# London. NW3 3DG

<b>Delegated Report (Members Briefing)</b>		<b>Analysis sheet</b>		<b>Expiry Date:</b>	<b>04/02/2021</b>
		N/A		<b>Consultation Expiry Date:</b>	<b>08/02/2021</b>
<b>Officer</b>			<b>Application Number(s)</b>		
Charlotte Meynell			2020/6010/P		
<b>Application Address</b>			<b>Drawing Numbers</b>		
37 Primrose Hill Road London NW3 3DG			Refer to Draft Decision Notice		
<b>PO 3/4</b>	<b>Area Team Signature</b>	<b>C&amp;UD</b>	<b>Authorised Officer Signature</b>		
<b>Proposal(s)</b>					
Erection of an additional storey at 3rd floor level on existing dwellinghouse.					
<b>Recommendation(s):</b>		Grant Prior Approval			
<b>Application Type:</b>		GPDO Prior Approval Part 1 Class AA

Erection of an additional storey at 3rd floor level on existing dwellinghouse.

**Drawing 9 (above): Proposed Front Elevation**

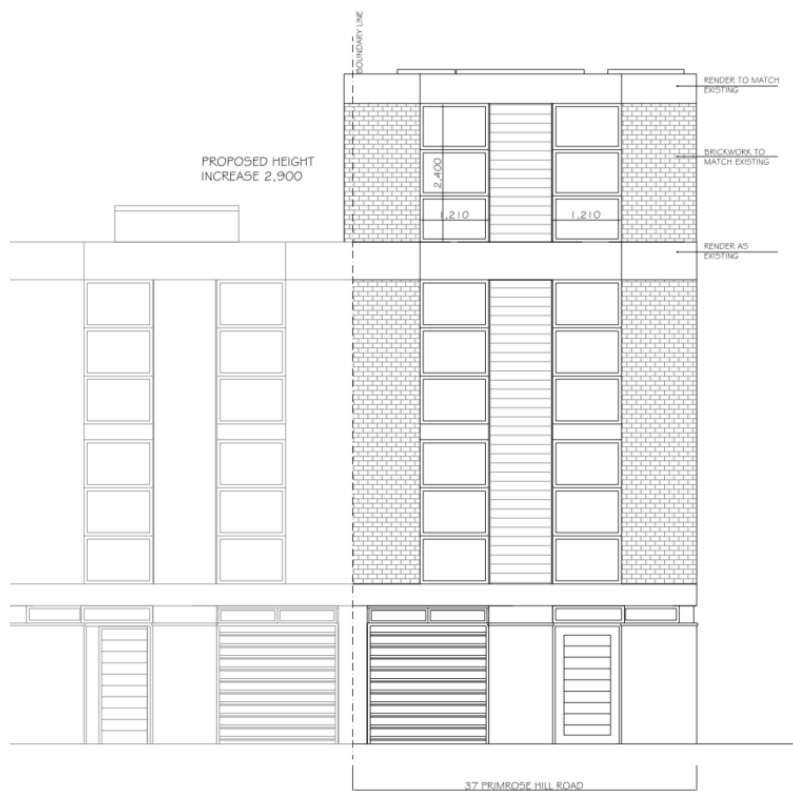
- 2.6. The proposal seeks to extend the main part of the building by one storey to create two additional bedrooms and two bathrooms at third floor level. The proposal would build up the principal front and rear elevations of the building and would not extend beyond the principal rear building line. The proposed floor to ceiling height would be the same (2.5m) as that of the existing ground, first and second floors below. Five rooflights would be inserted into the proposed flat roof in place of the existing four rooflights. The applicant has revised the scheme during the course of the application to remove the replacement roof storage box from the proposals. This is considered to be acceptable in design terms.

- 2.7. The proposal would match the existing building material pallet and detailing with dark red brickwork and a white render band above. This would result in an extension that blends into the existing fabric and the surrounding context. The proposed windows would be positioned to line up with the windows on the lower floors and would be of the same style as the existing windows. The proposal has been reviewed by the Council's Design Officers and is considered

**Drawing 10 (above): Proposed Rear Elevation**

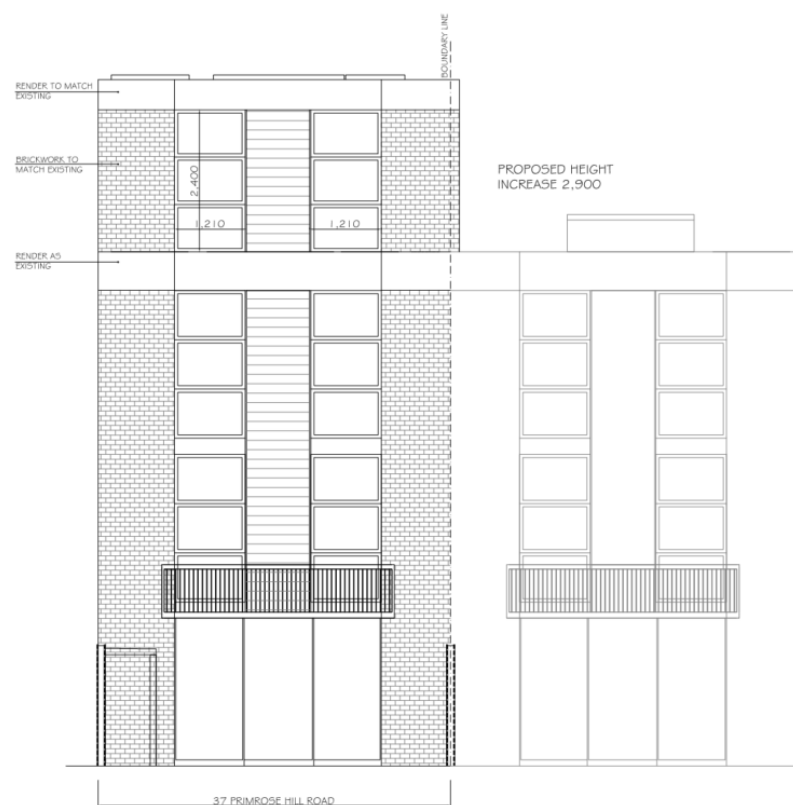
- 2.4. The additional storey would have windows at the front and rear. There are no buildings directly opposite the front of the site on the other side of Primrose Hill Road. To the rear, the host building directly fronts the windowless eastern flank elevation of No. 67 Quickswood. The remaining eastern flank elevations of No. 67 Quickswood face the rear of the adjacent neighbouring property No. 35 Primrose Hill Road, and there is a separation distance of between approximately 15-16m from rear building line of the host building and these flank elevations. It is therefore not considered that the proposed rear windows would result in a loss of privacy through increased overlooking into neighbouring habitable rooms of No. 67 Quickswood, given the separation distance and oblique angle.
